P.P.D (Regularization NO : 2039
L.O 2017) 2019

VIDE LETTER NO : Reg.L / 18893 / 2019
DATE : /11/ 2019

**IN-PRINCIPLE APPROVAL OF LAYOUT FRAMEWORK IN S.NO:134PT OF VANDALUR VILLAGE,
KATTANGALATHUR PANCHAYAT UNION AS PER G.O.(Ms) No:78 H&UD UD4 (3) DEPT. DT:04.05.2017 AND
G.O.(Ms) No:172 H&UD UD4 (3) DEPT. DT:13.10.2017 AND OFFICE ORDER NO.15/2018 DT: 12.12.2018.**

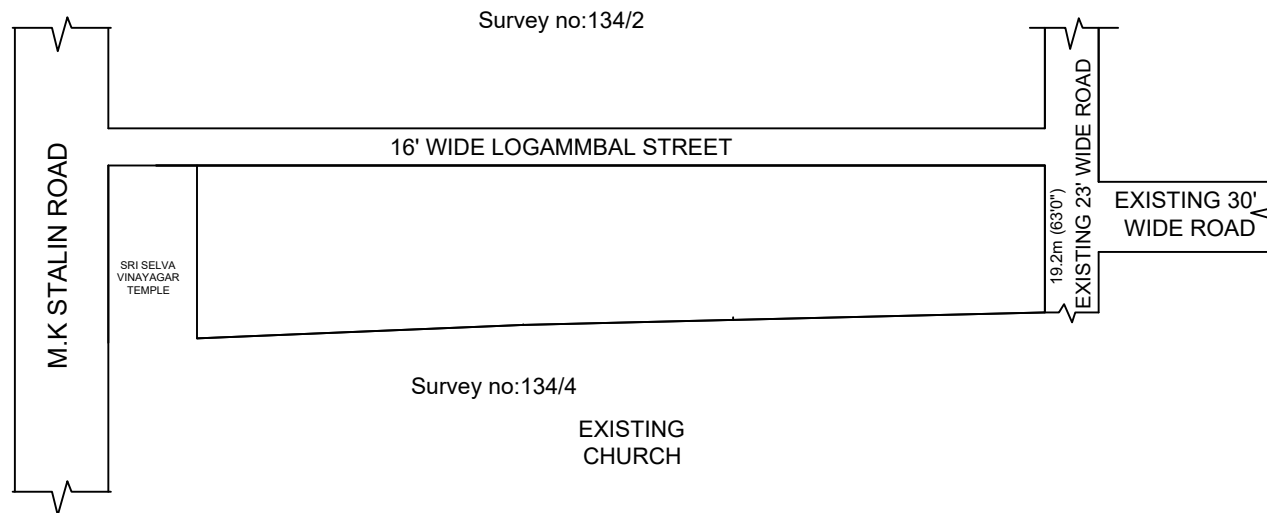
- 1) A SPLAY AT THE INTERSECTION OF TWO OR MORE STREETS / ROADS AND STREET ALIGNMENTS BE PROVIDED AS PER THE DEVELOPMENT REGULATIONS OF CMA.
- 2) KATTANKULATHUR PANCHAYAT UNION TO ENSURE THAT ALL THE ROADS ARE VESTED WITH THEM AS PER THE GOVERNMENT ORDERS.

- 8) S.No.134 of Vandalur Village is close to water body, Hence The Local Body has to obtain NOC from PWD on inundation point of view and NOC from Tahsildar concerned to be obtained that, the layout is not obstructing the water ways on the common fields irrigation on the ground, before regularization of individual plots in the layout under the reference.

- 9) The Regularisation of layout site was inspected by Kattankulathur Panchayat Union and forwarded to CMDA with recommendation to accord framework approval. As per the master plan the site under reference lies contiguous to water body as a primary landuse. Hence Kattankulathur Panchayat Union should ensure the layout is not part of water body before regularising the individual plot in layout.
